SYSTEM/MODEL: AP-M

MODIFICATION: Increase communication volume between master stations

INCREASE COMMUNICATION VOLUME BETWEEN AP-M MASTER STATIONS

AP-10M Schematic Diagram

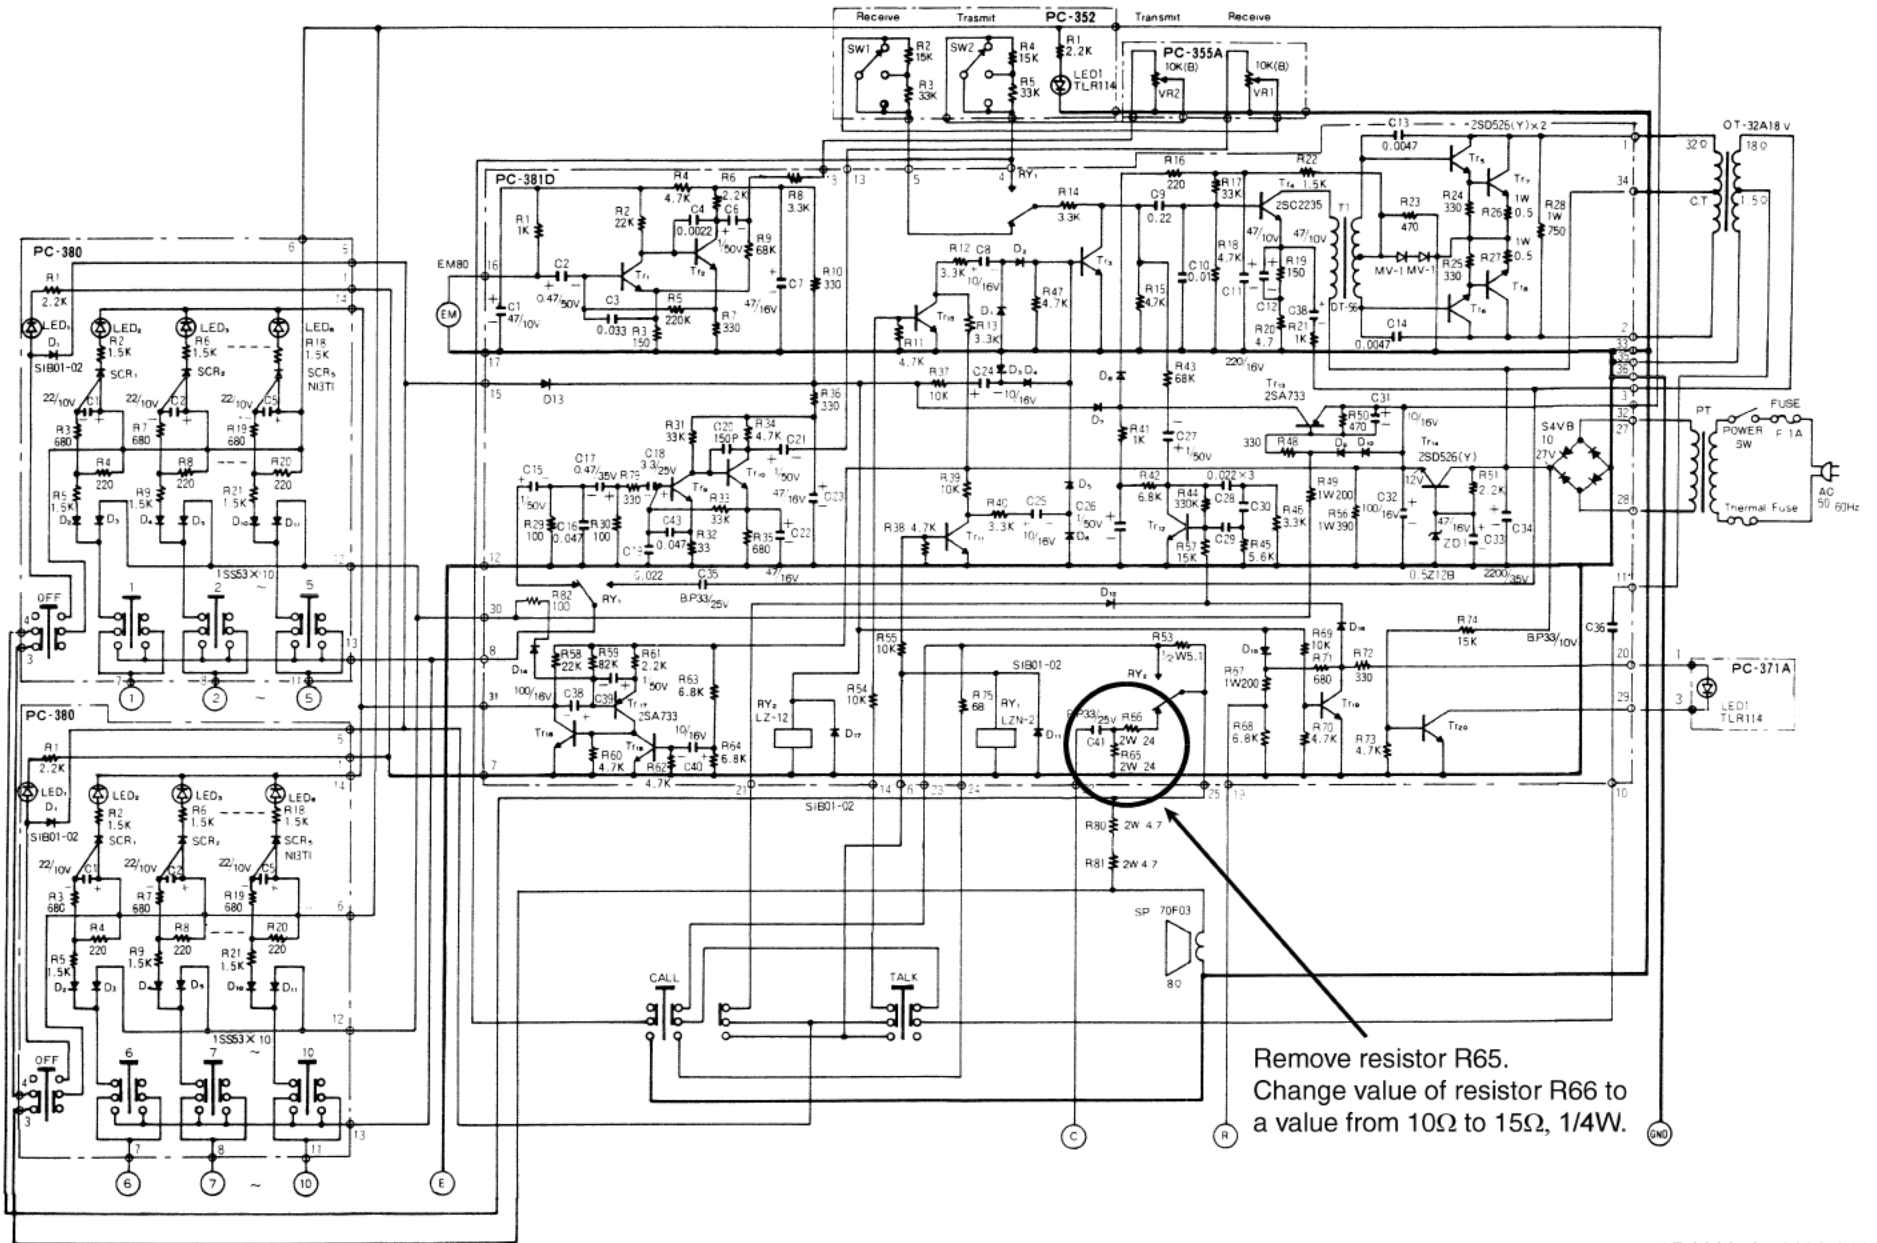
INSTR/OPERATIONS 1. Remove resistor R65.

2. Change value of resistor R66 to a value between 10 and 15 ohms to reach the desired volume level.

Remove resistor R65.
Change value of resistor R66 to
a value from 10Ω to 15Ω, 1/4W.
